IMPORTANT SAFETY RECALL

This notice applies to your BabyRide Infant Car Seat

NHTSA Recall 21C-001

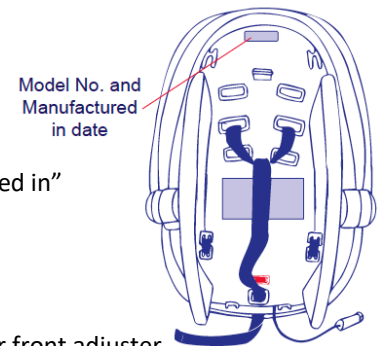
Combi USA has determined that the 1-inch-wide webbing strap used in the center front adjuster to snugly adjust the shoulder harness straps onto the child is below the minimum initial breaking strength requirements as specified in FMVSS 213. The webbing could fail to adequately restrain the occupant in the event of a vehicle crash.

Combi USA will be voluntarily providing a replacement 1-inch-wide center front adjuster strap and instructions to replace the strap free of charge. As a registered owner of a BabyRide Infant Car Seat, Combi USA will automatically send you a second notice along with a repair kit and instructions when they become available.
